ADDENDUM NO. 1
to
CONTRACT DOCUMENTS

for
ADDITIONS AND RENOVATIONS
to the
PRINCETON MIDDLE SCHOOL
located at 217 Walnut Lane, Princeton, NJ 08540

Issued: January 15, 2026

FVHD PROJECT NO. 5516B

B10

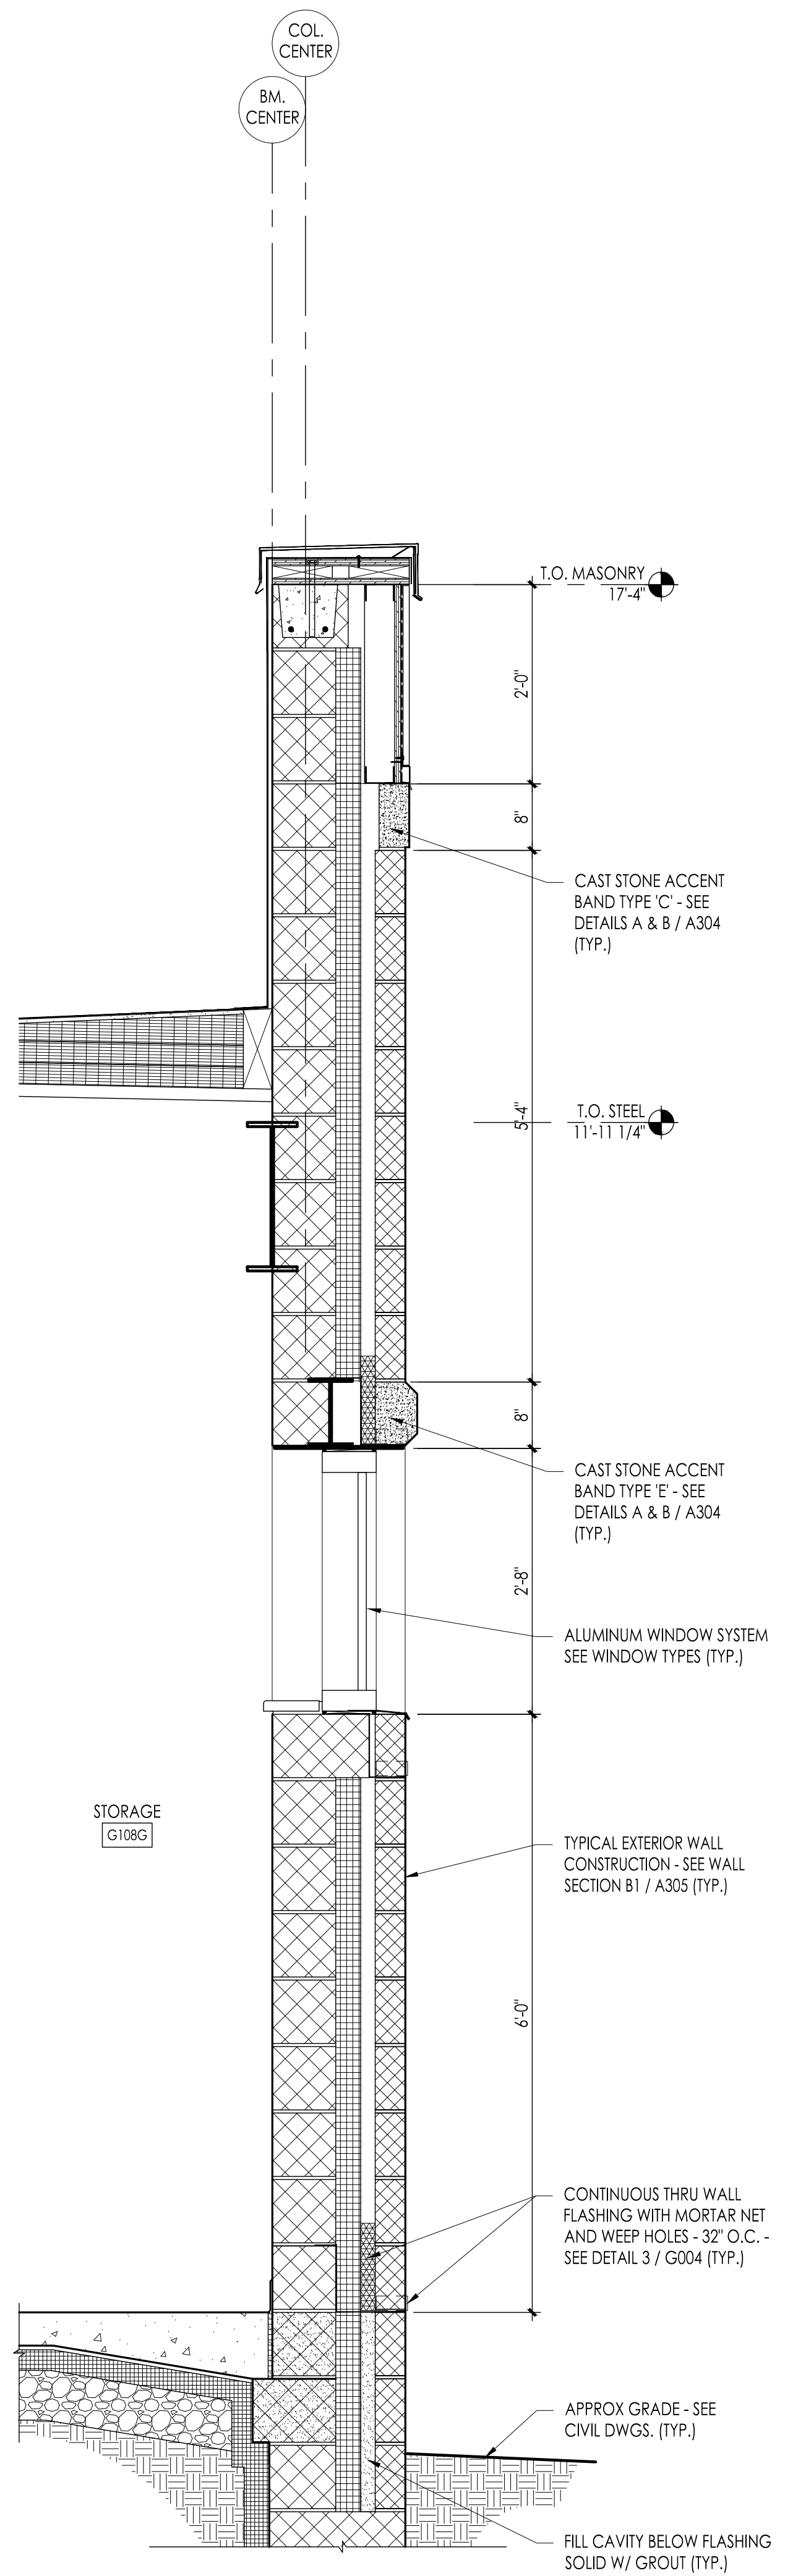
10. Question: Please confirm location of Overhead Doors, Specifications included, not on plans.

Response: Location and details are added to the drawings. See revised A105, A306, A601 and A602, attached to this Addendum.

Drawing Number
A400

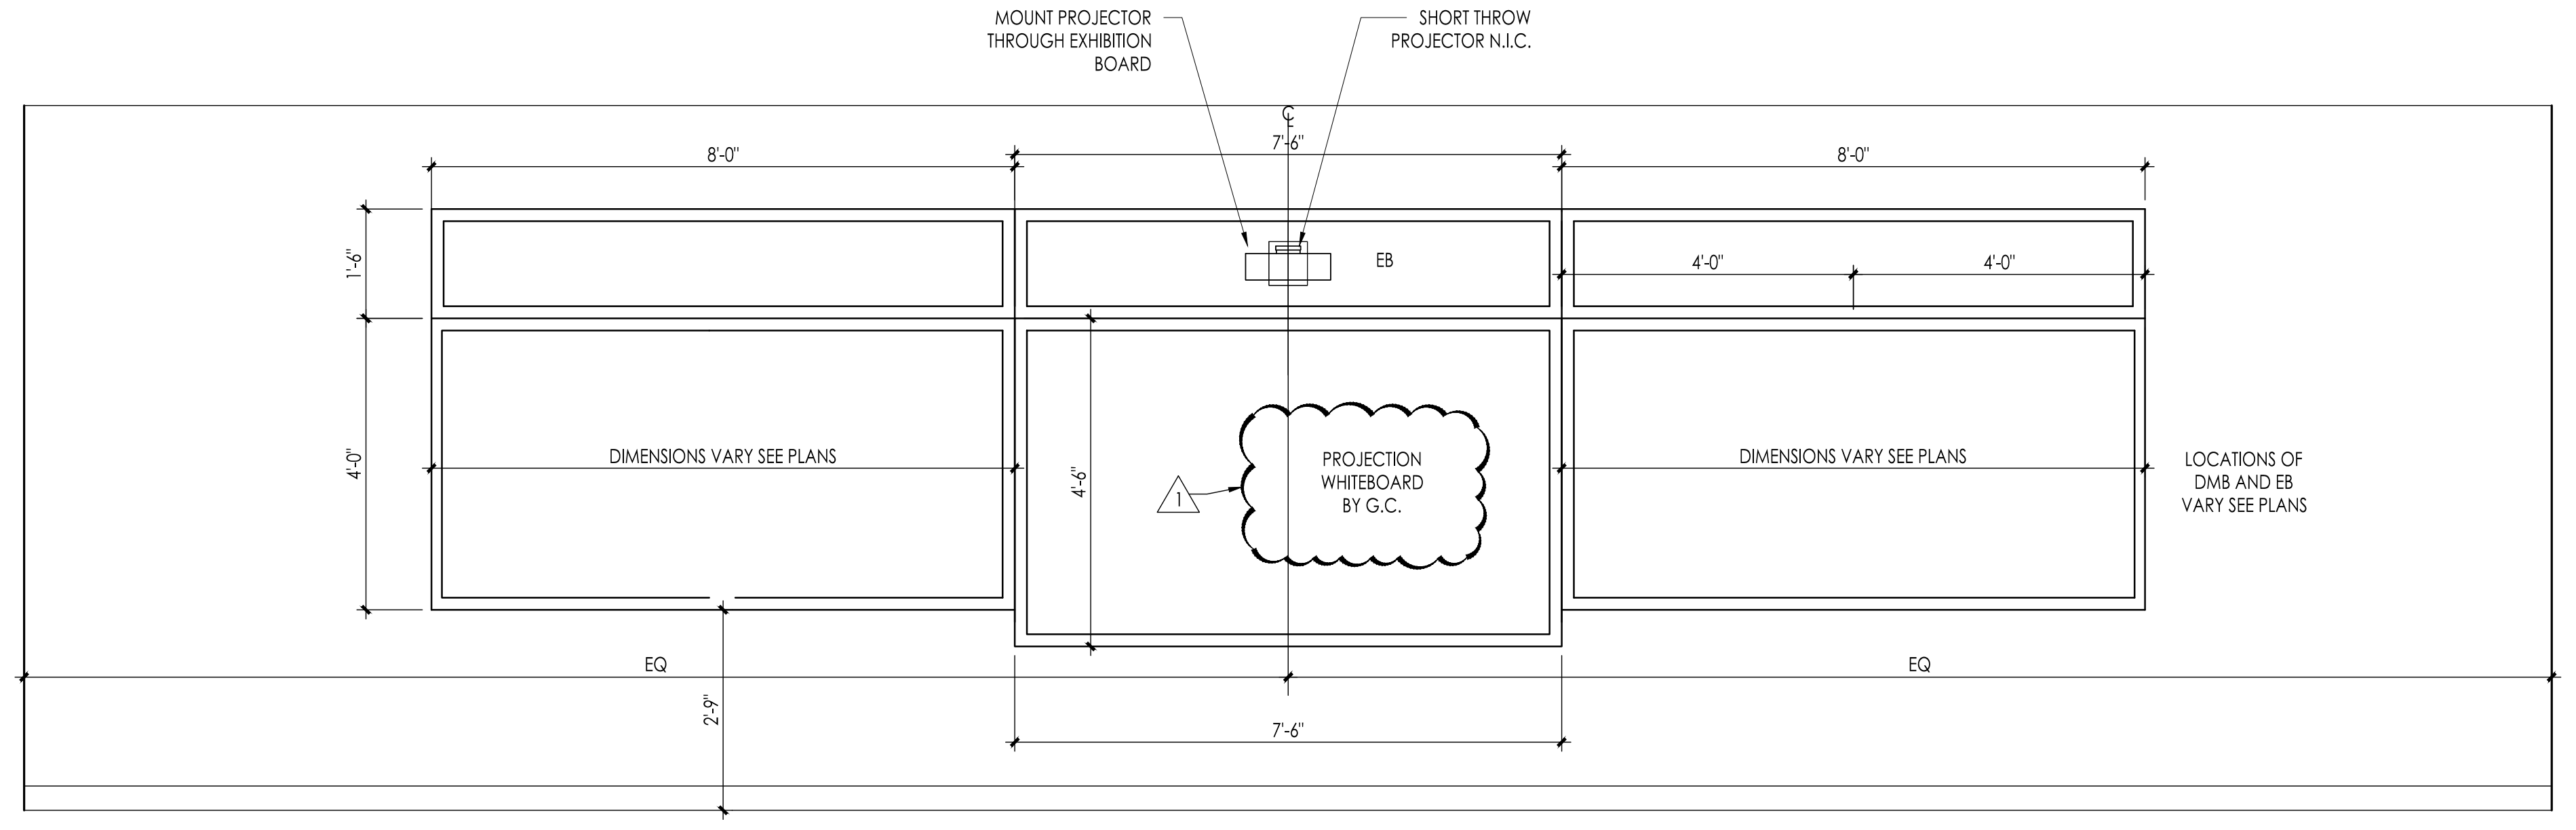
11. Question: Please confirm which Projector Screens are by GC, there are many conflicting notes in the plans.

Response: See revised A400 series drawings, attached to this Addendum.
    Wall and ceiling mounted projection screens are by GC.
    “Whiteboards” are by GC.
    Short-throw projectors are by Owner and not in contract.

Drawing Number
A602

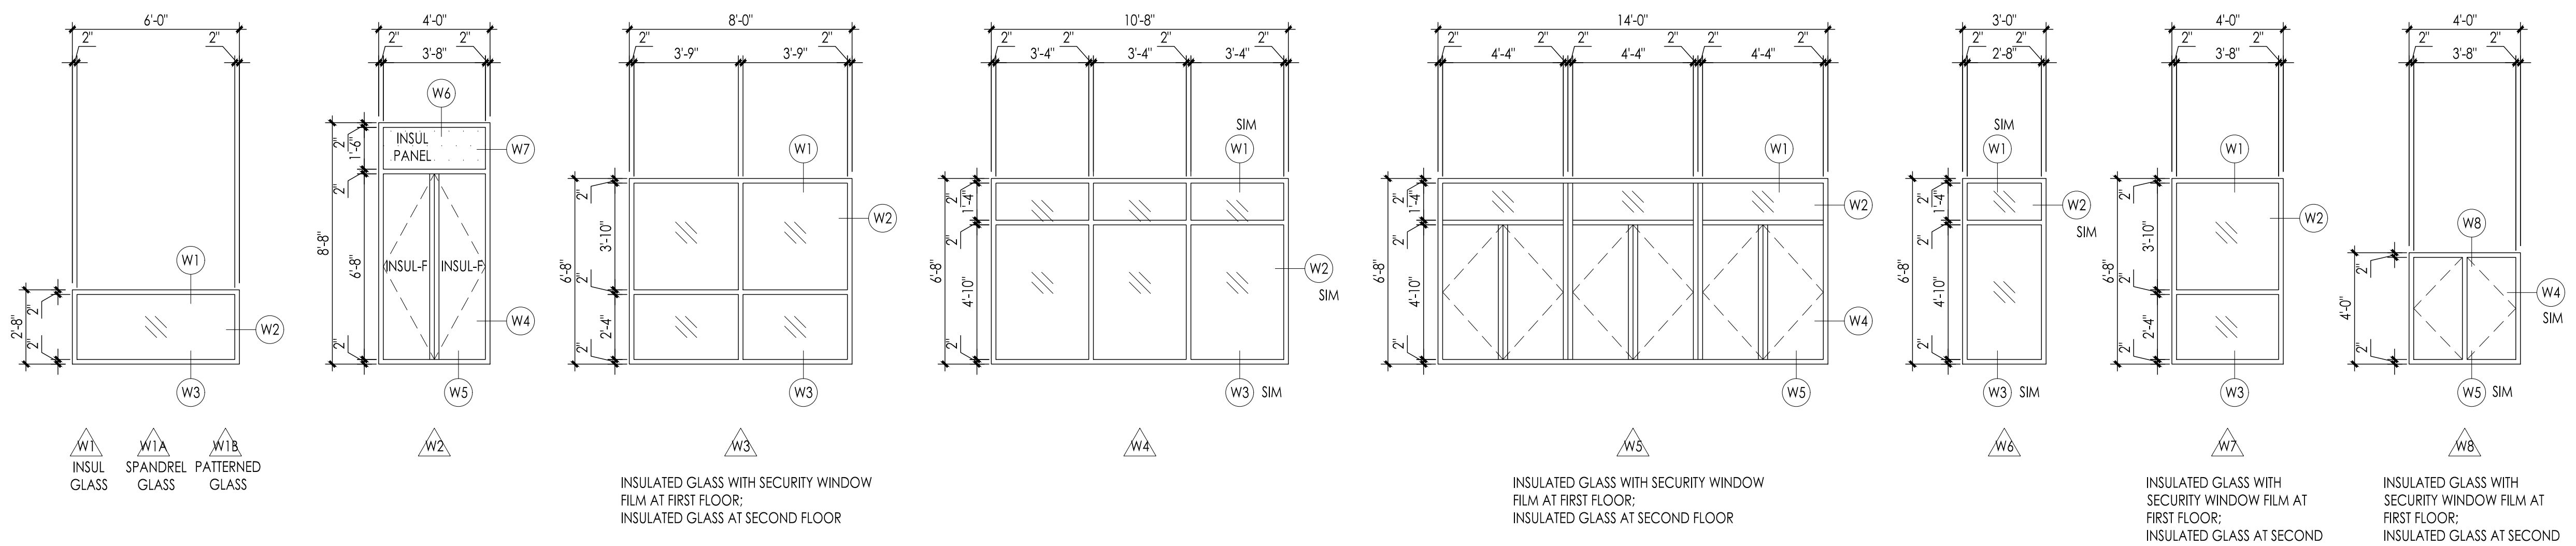
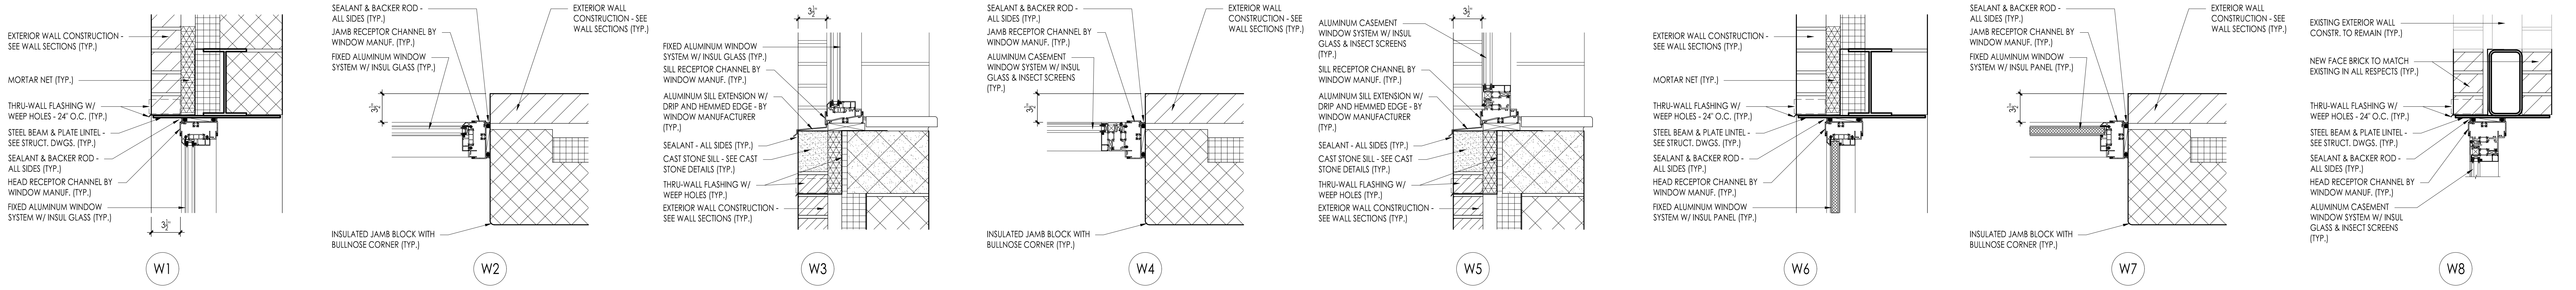
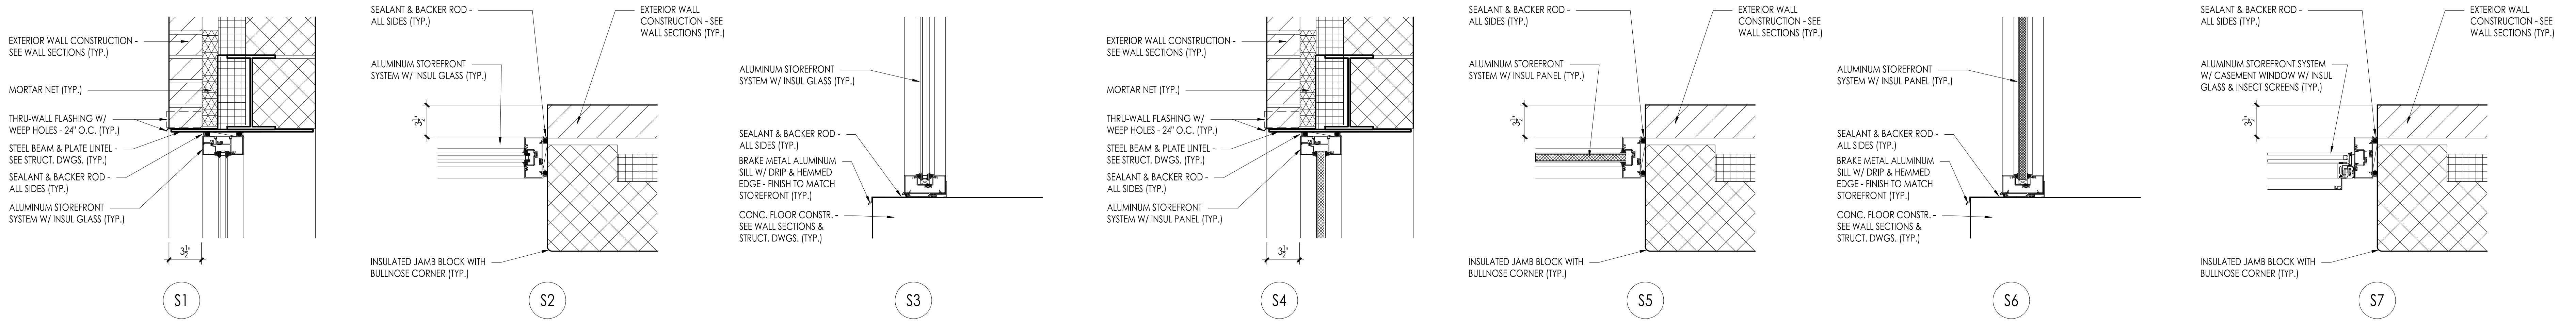
17. Question: Storefront Type # 3 on elevation A602 seems to have operable windows, but its drawn as SF in the detail S4/5/6. Only detail S7 shows a window, a casement on top of the SF. Please advise if these are SF frames with AW 3402i's set inside, or if there was another intention.

18. Question: Is SF2 a fixed AW 3402i's on storefront or is it all storefront as the details show?

Response: Storefront frame with Architectural Windows 3042i Casement Windows inset.
    (Note the window series is 3042i, not 3402i.)

Response: SF2 is storefront with spandrel glass and insulated panels as shown.
    (Note the window series is 3042i, not 3402i.)
